SUBJECT Update requested to the Auckland Unitary Plan
(Operative in Part 2016) (AUP)

Reason for update	Alteration to designation confirmed
Chapter(s)	Chapter K Vector Limited
Designation only	
Designation #	Designation 8866 – Sandspit Substation Vector Ltd
Locations:	Mahurangi East Road (Lot 1 DP 426584)
Lapse Date	31 August 2032 unless given effect to prior
Purpose	Substation
Changes to text (shown in underline and strikethrough)	Updates to conditions to reflect the changes to the site layout. Conditions that refer to plans have been updated to include new plans. Refer to attachments 2 and 3.
Changes to diagrams	Replacement Landscape plan. Refer to attachments 2 and 3.
Changes to spatial data	Adjustment to designation boundary. Refer to attachment 4.
Attachments	Attachment 1: Section 181(3) Auckland Council Recommendation and request from Vector Limited Attachment 2: Strike through and underline text Attachment 3: Clean text Attachment 4: GIS before and after alteration

Alteration to Designation 8866 – Sandspit substation under s181(3) of the Resource Management Act 1991

Figure 3: Updated designation boundary

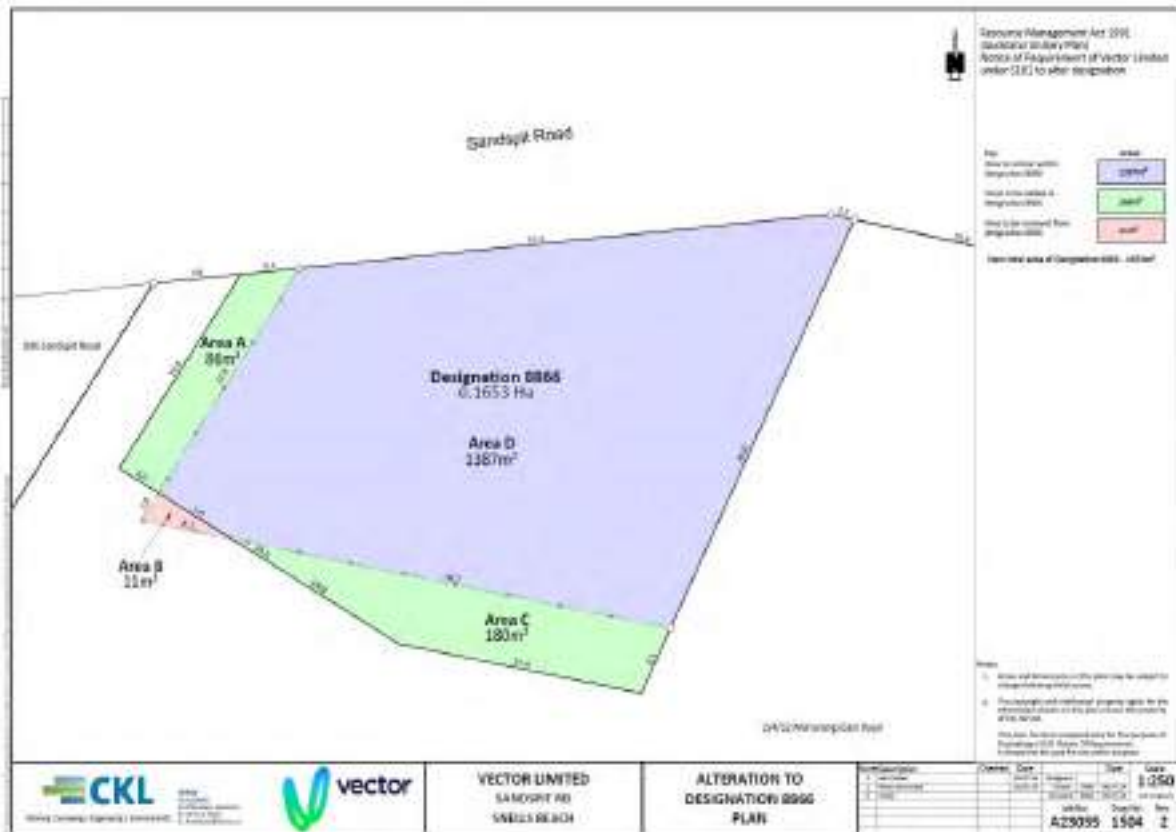
Figure 3: Updated designation boundary below illustrates the adjustments to the boundary.

I concur with Mr. Hay that the adjustments to the boundary are minor.

Proposed Vector Sandspit Substation Landscape Concept Plan

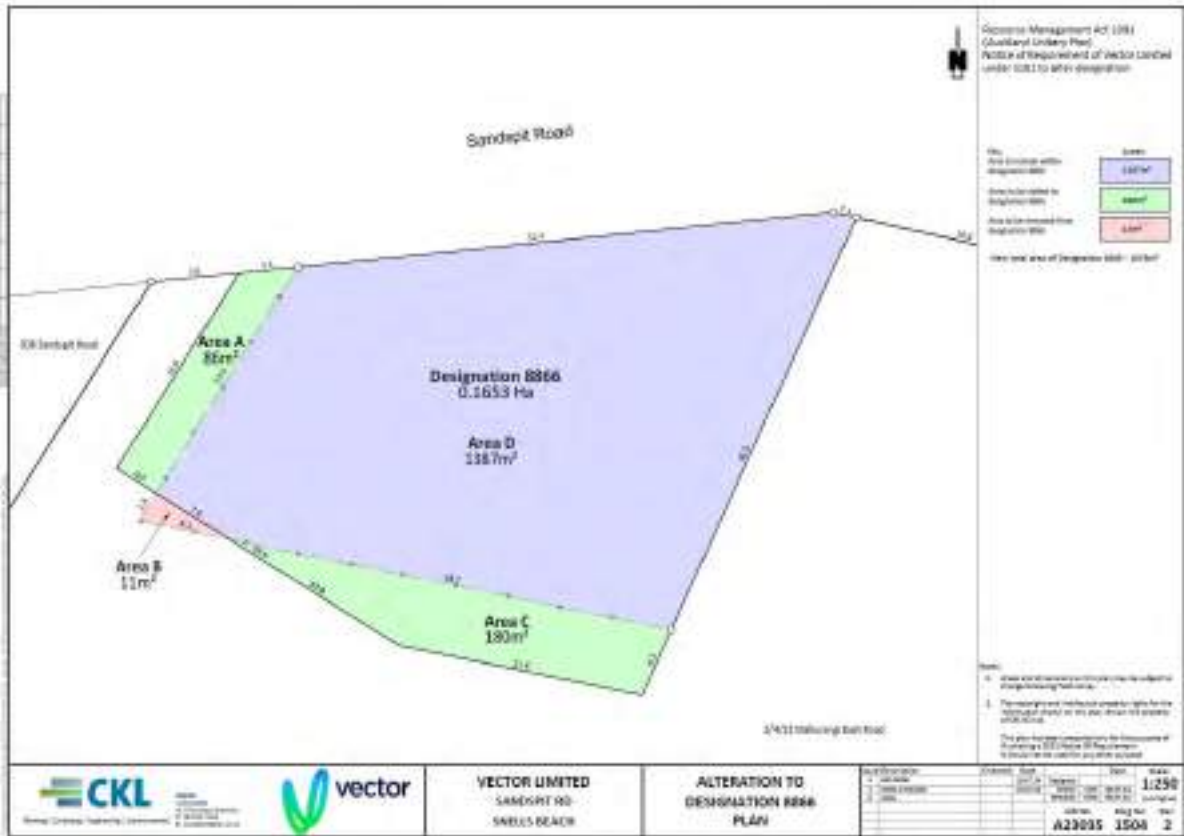
3. The landscaping plan (Isthmus Group Ltd, Drawing 01.01 Rev. Proposed Landscape Plan 2633, Figure 5, dated ~~29/4/2024~~ 6/07/09) shown in Appendix 15AA(i), shall be implemented during the first planting season after the construction of the substation. The landscaping shall be maintained thereafter.
